<b>Subject:</b>  SQUEAKING/GRINDING NOISE FROM REAR BRAKE	<b>Bulletin No:</b> 04-003/15
	<b>Last Issued:</b> 11/06/2015

2014-16 Mazda3 vehicles with VINs starting with JM1

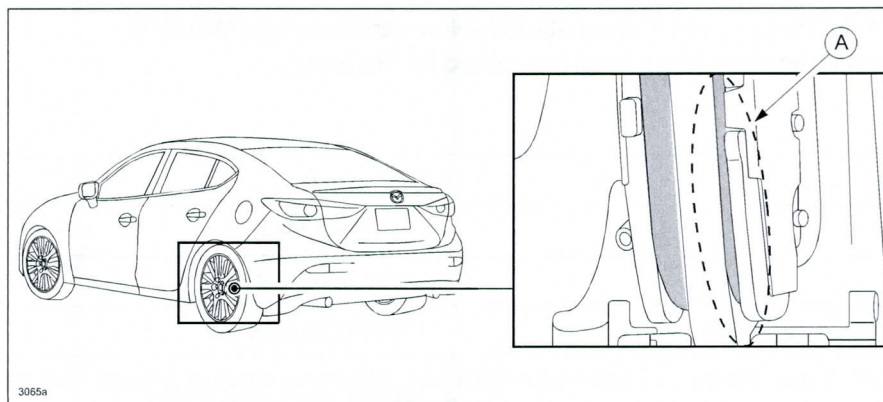
Some vehicles may experience a squeaking/grinding noise from the rear brake even after the brake pedal is released. Upon inspection, the caliper mounting support is corroded and the disc pad is abnormally worn out (A). This is caused by vehicle usage in an area using road salt. The surface of the mounting support may swell from corrosion causing premature disc pad wear and brake noise.

To correct the problem, an improved caliper mounting support has been newly established as a service part. The anti-corrosion surface treatment has been changed from Zn to Zn-Ni plating.

1. Verify that the caliper mounting support(s) is corroded and the disc pad(s) is abnormally worn out.
2. Replace the caliper mounting supports (both sides) with the modified service parts sets and attachments with new parts according to the instructions on MS3 online or the Workshop Manual (section 04-11 REAR BRAKE (DISC) REMOVAL/INSTALLATION).
